GLOBAL FIT (BANGLADESH) LIMITED

Plot # 868/1, Block - A, Jangalia Para, Vawal Mirjapur, Gazipur Sadar, Gazipur-1700
(24.092802, 90.384984)

17 January 2024

Observation 1: Connection adequacy of the shed. (Production Shed)

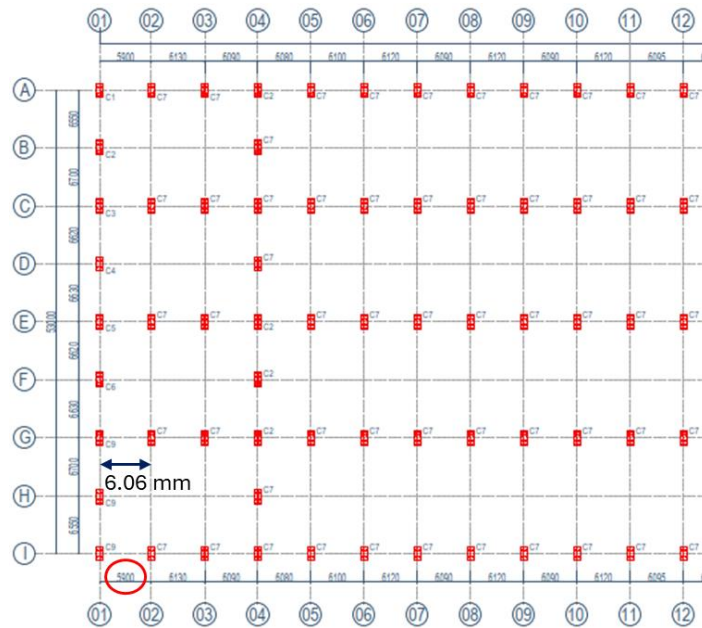
Description: The connection of the rafter is partially rigid. Full rigid connection was considered in the analysis. Building engineer is required to check the adequacy of the connection.

Mismatch in grid distance

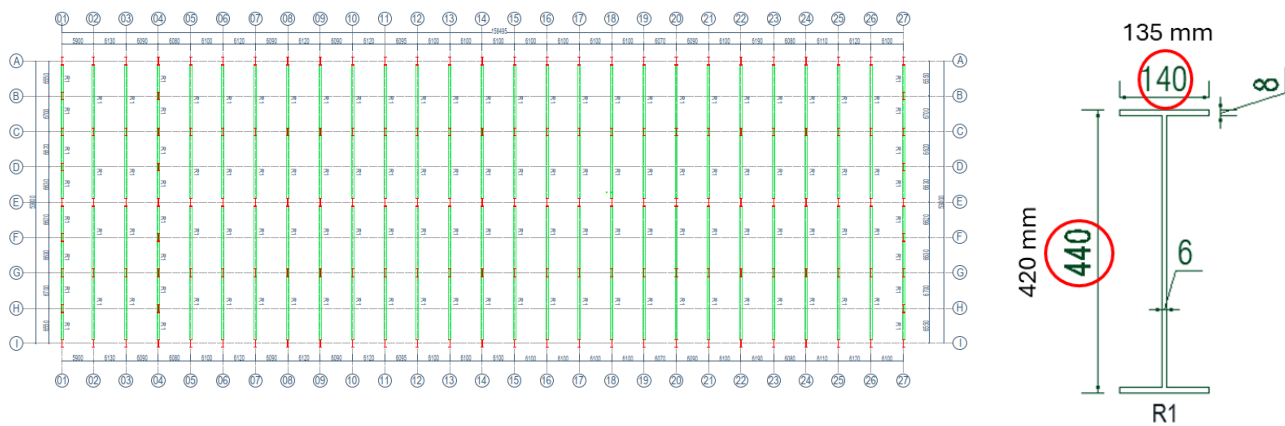
Description: In the as-built drawing, the mismatch was found in the grid distance, rafter size, eave & ridge height. Grid distance between Grid 1 & 2 is found 6.06m, whereas the drawing shows 5.9m. All rafter sizes are shown W-440X6, F-140X8 but during inspection, rafter size was found W-420X6, F-135X8 on-site. Eave height is shown 4.91m in drawing but 5.0m was found on-site.

Inconsistency in material strength consideration

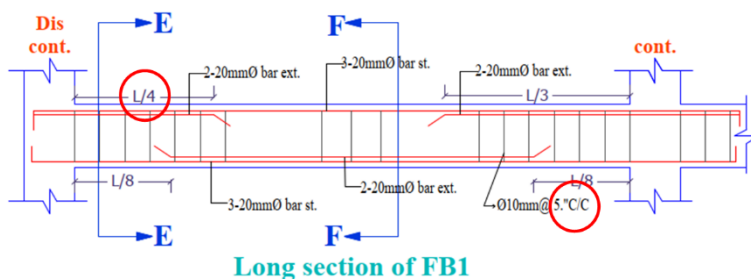
Description: As per design report, existing concrete strength for both beam and column is taken 2993 psi. Despite having concrete cores from slab, concrete strength of slab is taken same as equivalent concrete strength of columns. Since, construction drawing was not found on-site, design strength of columns and slabs cannot be verified. The building engineer is required to revise the material strength considerations for beams and slabs and give necessary justifications for not taking strengths of concrete cores obtained from slabs.

Inconsistency in live load consideration

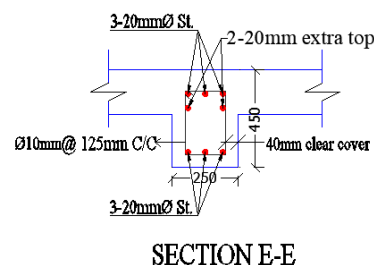
The strength of retrofitted concrete is taken 3500 psi, but no test is carried out to verify the concrete strength. In design report, roof live load is taken 1 kPa (21 psf) but as per BNBC 2006, roof live load is 1.5 kPa (31.5 psf). In design report, Intermediate moment resisting frame is considered but stirrup spacing of grade and floor beams doesn't comply with IMRF consideration of BNBC 2006.

Observation-7: Mismatch in as-built drawings. (Toilet Block)

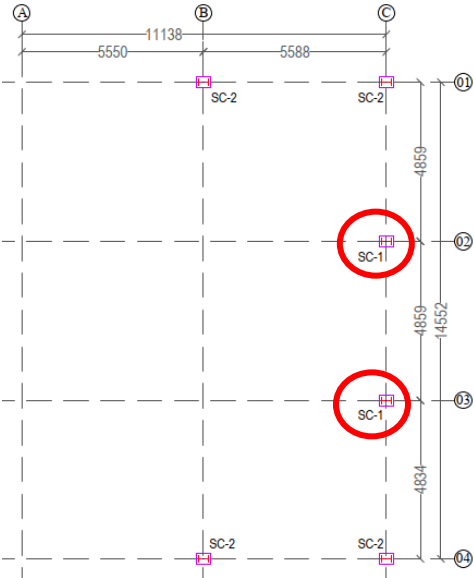
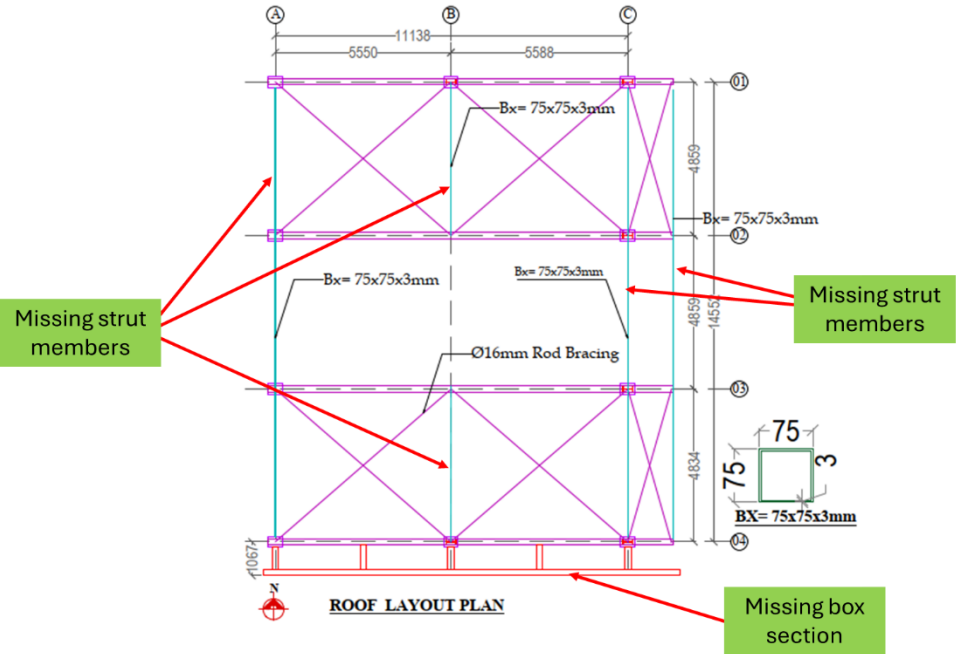
Description: During the inspection, the mismatch was found in the as-built drawing. Strut members are shown in the as-built drawing, but during the inspection, strut members were found missing on-site. A steel rafter supported by the cantilever rafters was found missing on-site. Sizes of steel column SC-1 is shown as W-316X5, and F-200X8 in the drawing, but column size was found W-316X5, and F-150X8 on-site.

Mismatch in the as-built drawing

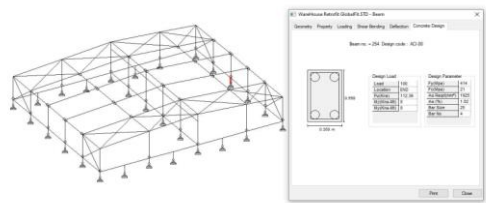
Description: Mismatch was found in the as-built drawing. The depth size of C1 was measured 390mm instead of 420mm and flange thickness was measured 6 mm instead of 8 mm.

Observation-11: Inconsistencies in design report. (Warehouse)

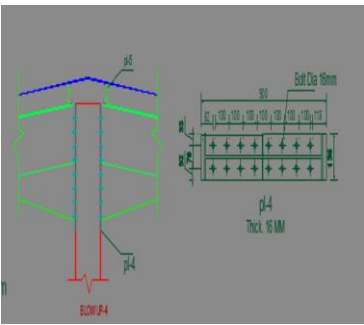
Description: The steel strength is considered as 415 MPa in design analysis but in the material strength chapter it was considered as 323 MPa. Also, no test report was provided for the 415 MPa rebar. Also in the connection adequacy chapter, the type of connection is shown as not matched with the site condition.

Inconsistencies in design report. (Warehouse)	Building engineer is required to prepare the design report following the provision of BNBC 1.9.	within 6 weeks
	Carry out remedial work if required.	within 6 months
Mismatch in the as-built drawing. (Utility Building)	The building engineer is required to survey the structure, collect information, and prepare accurate as-built drawings.	within 6 weeks
